SERVICE BULLETIN

M-951

JULY 25, 1987

TIRE VALVE

Figure 1. Measure valve

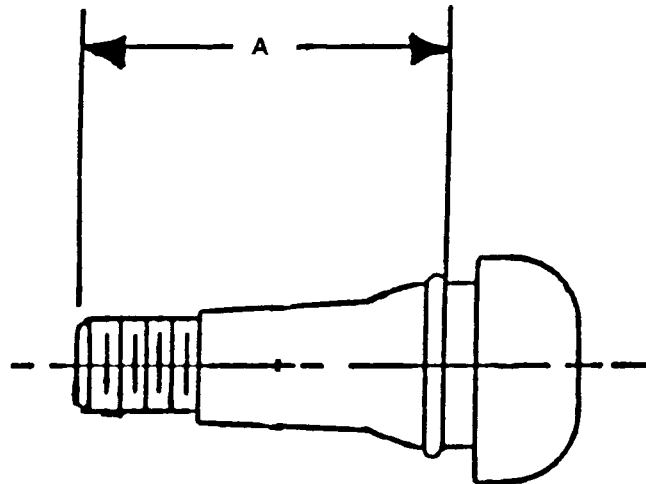
The Harley-Davidson Tire Valve Kit part no. 40999-87 may contain either a 1-1/4 in. long tire valve (stamped 413 on valve bottom) or a 7/8 in. long tire valve (stamped 412 on valve bottom). The valve stamped 412 is the correct valve for Hayes brake equipped vehicles. The longer valve could come into contact with the Hayes rear brake caliper during normal operation.

Repeated valve contact with rear brake caliper could cause valve failure resulting in loss of air pressure which would lead to handling difficulties.

See Figure 1. If the rear tire valve has been replaced on Hayes braked equipped vehicles measure the valve from the wheel rim to the tip of the valve (dimension A). If the valve measures 1-1/4 in. replace it with the 7/8 in. valve.
